STRONGER, EASY TO INSTALL NUKLIP SHOPFRONT BEAD

June 2015
Technical Bulletin 41

RE-DESIGNED SHOPFRONT BEAD

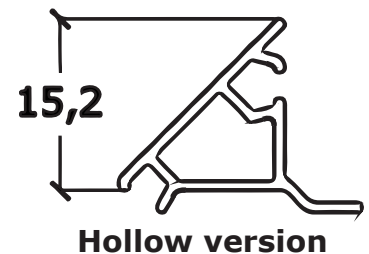
The diagrams below indicate the current & future alternative interchangeable designs of the NuKlip bead LMSL.

-  Hollow design offers improved strength
-  Small adjustments to gasket slot size facilitated easier "slide-in" of butterfly gasket
-  Hollow design is fully interchangeable with solid version - no stock challenges
